Our Case Number: ACP-323977-25

Re: The proposed expansion of the existing landfill facility at the existing Knockharley Landfill in the townlands of Knockharley, Flemingstown and Tuiterrath Navan, Co. Meath

SID Planning Submissions Response Report

Figure 3 – Extract that explains the compensatory storage approach (Source: *The Planning System and Flood Risk Management - Guidelines for Planning Authorities - Technical Appendices, Nov 2009. Appendix B: Addressing Flood Risk Management in Design of Development*)

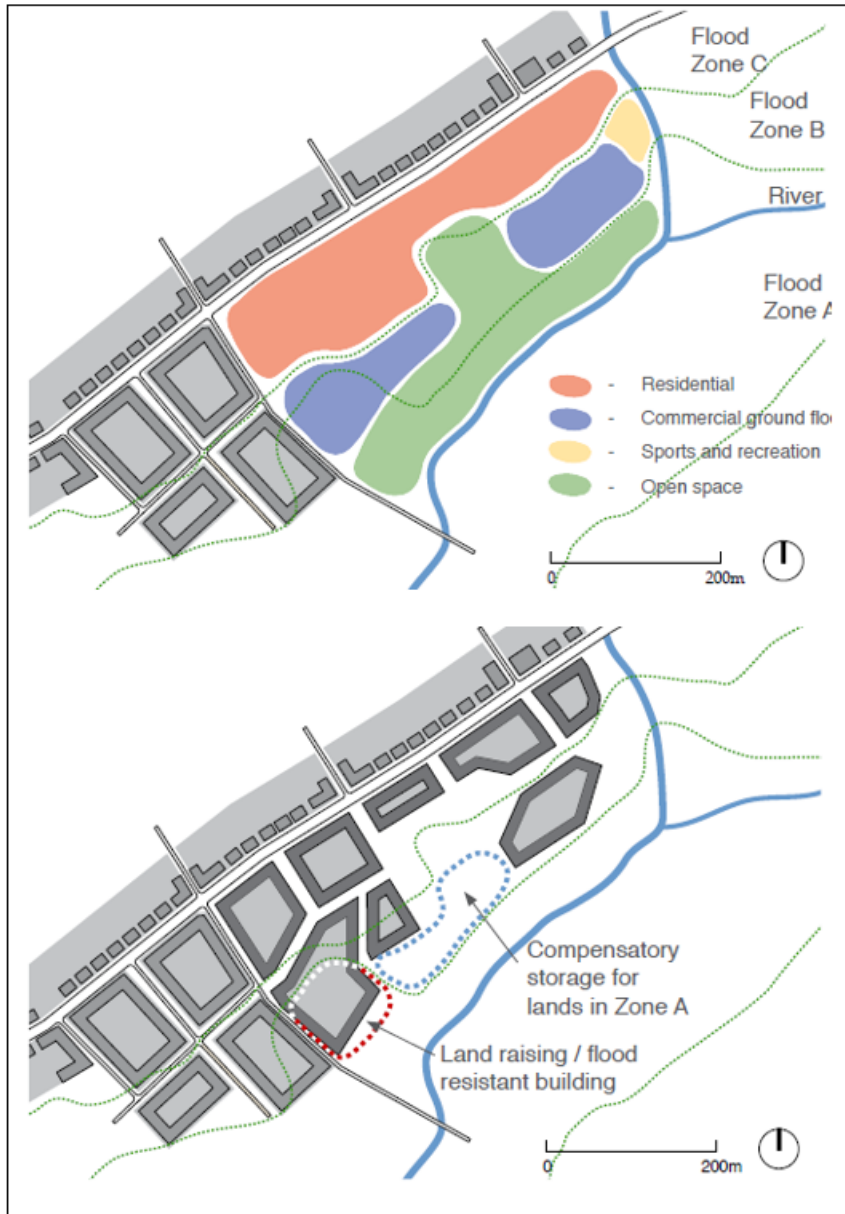
1. *Having regard to Meath County Development Plan in which it is a policy to consider the DOEHLG / OPW publication 'The Planning System and Flood Risk Management, Guidelines for Planning Authorities' and with reference to OPW CFRAMS mapping and Meath County Council's MapInfo flood mapping for the relevant area the proposed development site is partially situated in Flood Zone A, i.e. it is at high risk of flooding. In accordance with the aforementioned guidelines the applicant shall submit a Site Specific Flood Risk Assessment (SSFRA) and apply the 'development management Justification Test' as set out in Chapter 5 of the same guidelines to rigorously assess the appropriateness of the proposed development and shall submit all matters relating to this Justification test and all matters relevant to flood risk relating to the proposed development site to the Planning Authority for their further consideration. The applicant shall submit detailed hydraulic modelling of the proposed diverted Knockharley stream as part of a revised SSFRA and establish flood zones A&B on the*

subject site. The applicant shall also provide detail calculations regarding compensatory storage and agree in writing with the planning authority a suitable location for the compensatory storage as the applicant is proposing to locate earthen berms to the north of the Knockharley river. The applicant shall also ensure that any area selected for compensatory storage will be free from stockpiles of potential contaminants or pollutants.

Applicant Response: With reference to OPW CFRAMS mapping and Meath County Council's MapInfo flood mapping for the relevant area it is noted that the south-eastern corner of the overall site is partially situated in Flood Zone A (see figure 1 below). Importantly, there are no works proposed within the Flood Zone A (flooding probability of greater than 1% or 1 in 100) area located on the overall site. As can be seen from figure 1 below, neither the attenuation pond footprint, which was the basis of the original compensatory storage requirement, nor any elements of the proposed new development subject to this planning application lie within Flood Zone A.

National Planning Guidelines published by the OPW (2009) state, in Appendix B 3.3.1 that: *“in general, level for level compensation should only be applied in areas where flood water is stored. Floodwater is stored in most natural and defended floodplains which are inundated in the 1% AEP event. It is important to ensure flood flow routes should be protected, whatever the cause of flooding. In some circumstances, this is more critical than providing level for level compensation”*. From the foregoing, it can be inferred that compensatory storage is only applicable to cases where the 1% AEP flood zone extent (i.e., **Flood Zone A**) is intervened. Figure 2 below extracted from the 2009 Guidelines explicitly explains this approach.

It is noted that the previous application for development identified the ability to provide for additional compensatory storage within proximity to the Flood Zone B lands (flooding

probability of between 0.1% or 1 in 1000 and 1% or 1 in 100). In accordance with the relevant guidelines above, this compensatory storage is not required to be provided for the development, as such, the land area is proposed to be developed with landscape bunding, the impacts of which have been fully assessed in the submitted Site-Specific Flood Risk Assessment.
